2018 Mercedes Benz E63S AMG 4MATIC Sed (213.089) V8-4.0L Turbo (177.980)

CHECK CAMSHAFT COVER, ADJUST IF NECESSARY MODELS 172, 205, 213, 253 MODEL YEAR 2018

Service Campaign Bulletin

Campaign No. 2017100008, November 2017

**Figure 1****Figure 2**

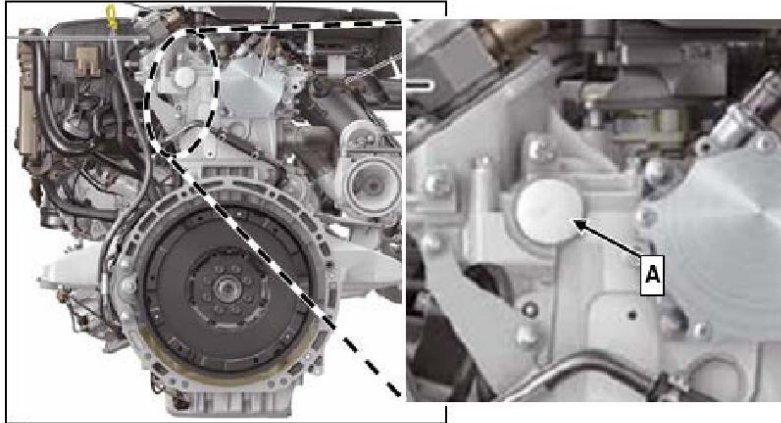
1. Open hood and check cover (A, figure 1) of camshaft.

i The cover **must** be flush **all-round** in the cylinder head housing.
If necessary, press on cover again using a suitable plastic wedge (1, figure 2).
The replacement of the cover is **not** required!
